ANN ARBOR HISTORIC DISTRICT COMMISSION

Staff Report

ADDRESS: 408 South First Street, Application Number HDC18-232

APPLICATION: The applicant seeks HDC approval to enlarge an existing basement window on the south elevation to provide egress, and replace another basement window with glass block.

EGRESS WINDOW WELL SECTION

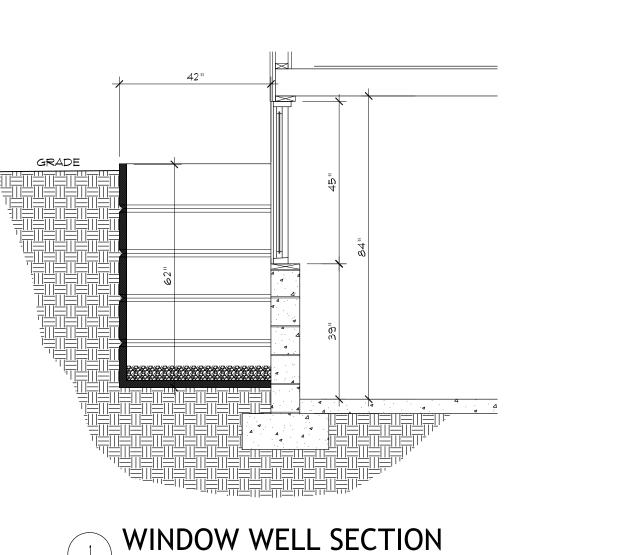
- 2. The well is a prefabricated polyethylene unit with built in steps. It extends a few inches above grade in a U shape. A section drawing and plan views are provided. No cover is listed as part of the application. The egress window is 27" wide by 45" tall, and swings in. Detail is shown for the window and well, with new wood that replicates the existing jamb and header width and depth.
- 3. A new glass block window is proposed to replace an existing wood window on the north elevation. A window would be in a new shower. The location meets the criteria for staff approval (the existing opening size remains the same, and the glass is recessed to the same plane as the original glass).
- 4. Staff supports the application since the location of the well is appropriate, the egress window makes use of the existing window opening's width, and the glass block window utilizes the existing opening.
